## Product Change Notification

**1. ECR #:** 164011  
**Notification #:** 331

**3. Series:**  
• BCS - BOX CONNECTOR SOCKET STRIP

Before and after image of body component BCH-XX-D

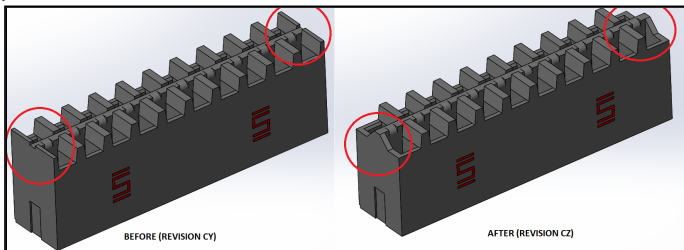
**5. Description of Change:**  
Reduction in size of end-walls of the plastic insulator housing. This will be a rolling change (inventory at current revision will be exhausted prior to implementation).

**6. Method of Identifying Change**  
This change is visible with the unaided eye. New SSM-1XX-XXX-DH-XX-XX-XX-XX will have reduced plastic volume on the end walls and a new chamfer added.

**7. Reason for Change:**  
This change eliminates non-functional thin plastic that has a history of breaking.

**8. Impact of Change on Form, Fit, or Function:**  
• Form - The change will be visible with the unaided eye. There are no anticipated changes to fit or function.
